# Referral Response

## City Strategy – Open Space Design

<b>Referral Officer:</b>	Greg Cater
<b>Officer:</b>	Nish Goonetilleke
<b>Council Reference:</b>	PPE23/0571
<b>Address:</b>	300/658 Church St, Cremorne VIC 3121
<b>Proposal:</b>	DEECA Referral
<b>Comments Sought:</b>	Click here to view referral memo:
<b>Disclaimer:</b>	Council's City Strategy - Open Space Plan & Design Unit – Open Space Planner, provides the following referral advice based on the information provided in the referral request memo referenced above.
<b>Prev. Responses:</b>

Figure 1

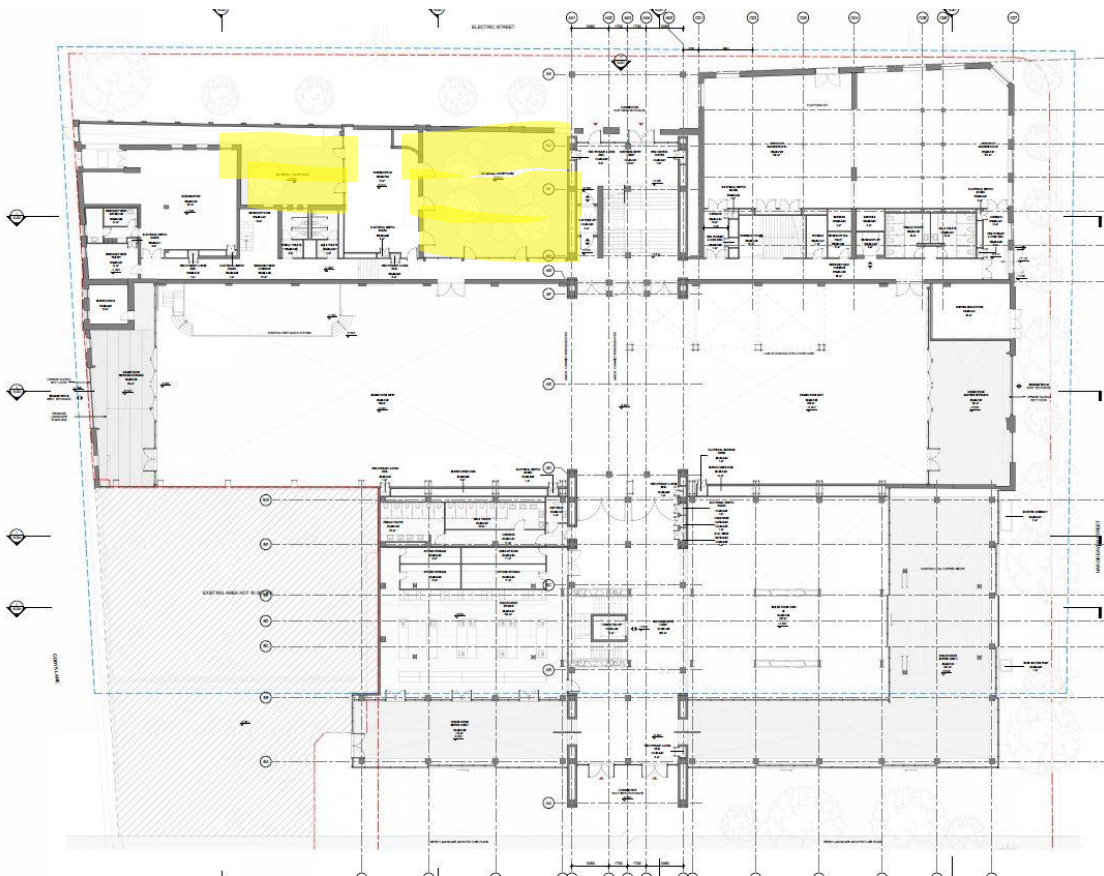
The landscape plans by Teresa Moller Landscape Studio, dated November 2023, are confusing to read and lack basic details. They concentrate on the new landscape associate to be implemented in the existing car park. There is no plan showing any information on the internal courtyard spaces on the north side of the building. Refer Figure 1.

The colour scheme for the surface materials is difficult to read and lacks differentiation. It is assumed that the existing asphalt car park is to have sections cut out for the planting. There is no information on any potential soil contamination from the car park and this should be investigated.

The proposed rain gardens lack any detail on their construction or functionality. This relates to the drainage of the site. Simple sections of the rain gardens and through the site would greatly assist. While the existing drainage is shown on L04, there is no understanding of how the drainage is to work, especially as they are proposing to fill the lower south-east corner of the car park.

Figure 2

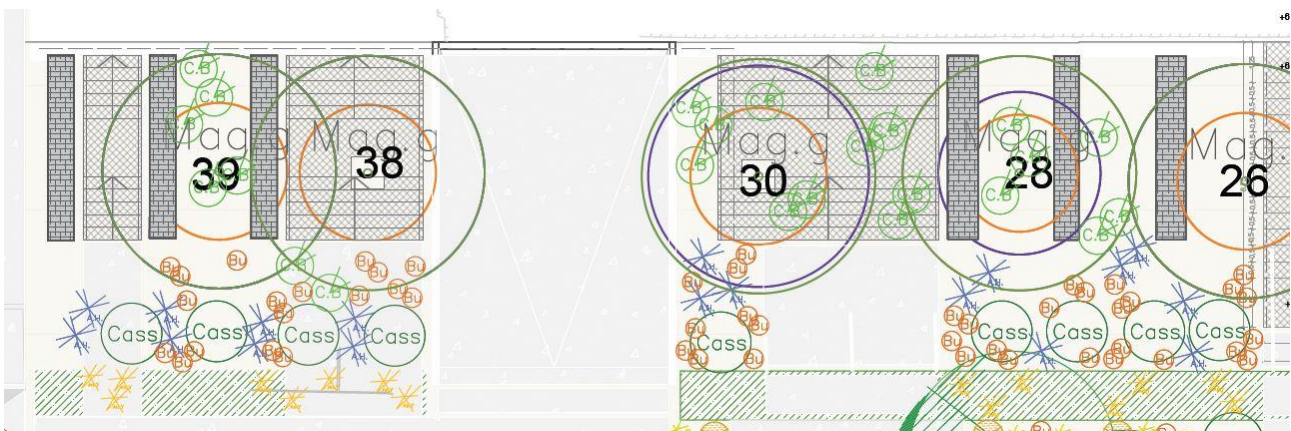
There are trees and ground cover plants proposed for the steps leading into the building. The cut outs for the trees don't align with the step treads and there is an understanding of how the ground cover plants are to be installed. Refer Figure 2.

**Figure 3**

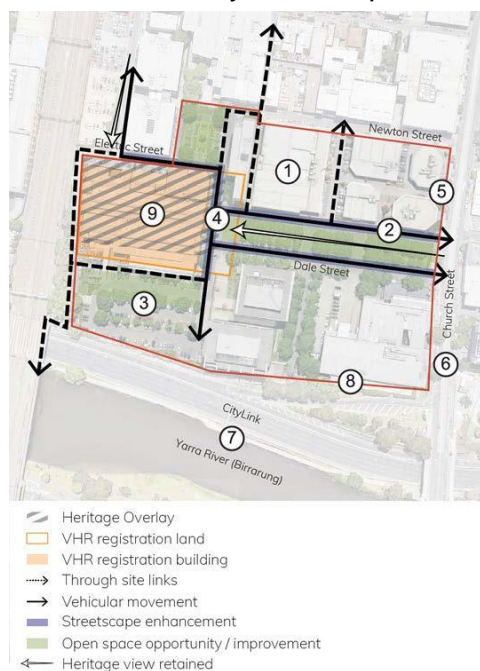
The ramp/steel stair structure needs more detail. Is it providing disabled access to the building? Difficult to understand how the ramp and stairs work. It needs a simple 3D model to show how it works. Question whether steel stairs are suitable given Australian summer

climate. These could potentially heat up and be a hazard for people sitting on them. It is also difficult to understand how the tree no. 24 will work with the structure.
